# Work Order ID 112778

Item Name: Crosstube Turning Detail

| DRAWING NO.<br>D212-664-241 | TITLE<br>CROSSTUBE ASSY (205/212 HI AFT) | REV. D        | DART AEROSPACE LTD.<br>ENGINEERING ORDER |               | D.E.O. NO.<br>D212-664-241-D-1 | SHEET NO.<br>SHEET 1 OF 2 | SCALE<br>NTS |

ADD AN INSPECTION WINDOW TO UNDERSIDE OF CROSSTUBE.

**D212-664-241/-241B  
ASSEMBLY DETAIL**

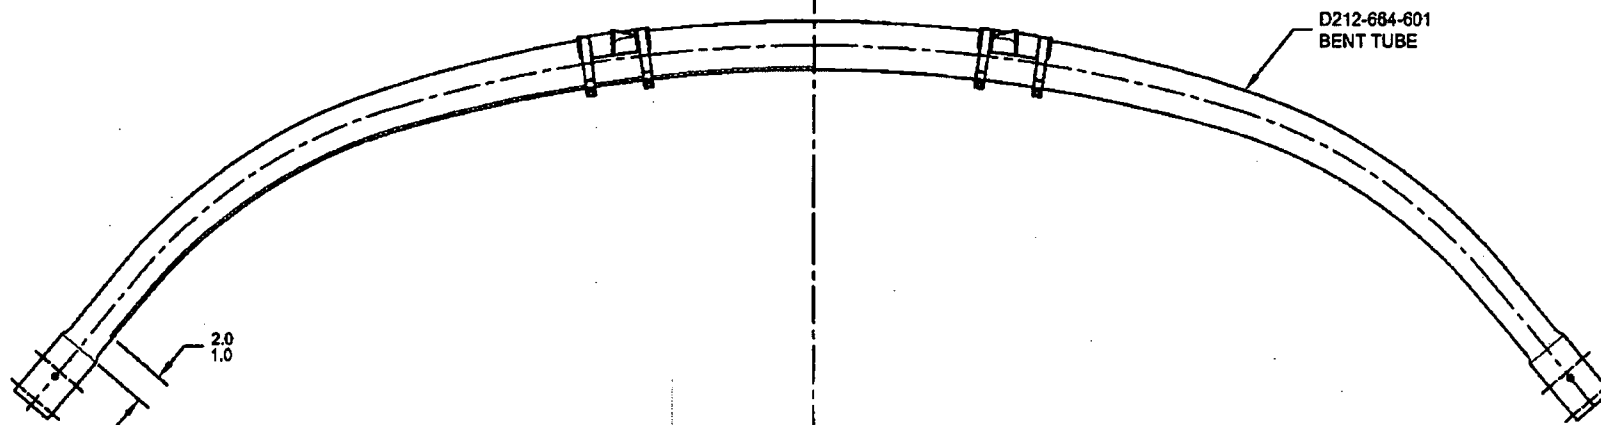
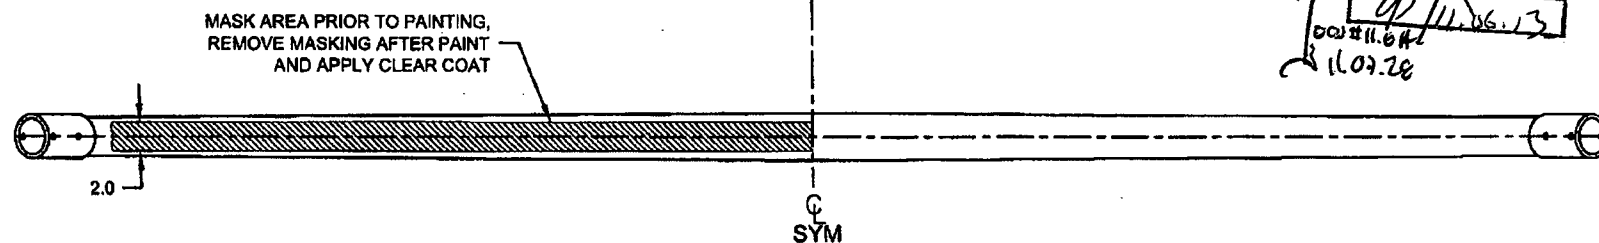
**PURPOSE:**

NOTES 2 OF SHEET 1 IS AMENDED AS FOLLOWS:

- 2) FINISH: CHEMICAL CONVERSION COAT PER DART QSI 005 4.1  
PRIME INSIDE AND OUTSIDE PER DART QSI 005 4.2  
MASK UNDERSIDE OF CROSSTUBE AS SHOWN (HATCHED AREA) AND  
PAINT OUTSIDE PER DART QSI 005 4.2  
REMOVE MASKING AND APPLY CLEAR COAT

- 2) FINISH: CHEMICAL CONVERSION COAT PER DART QSI 005 4.1  
PRIME INSIDE AND OUTSIDE PER DART QSI 005 4.2  
PAINT OUTSIDE PER DART QSI 005 4.2
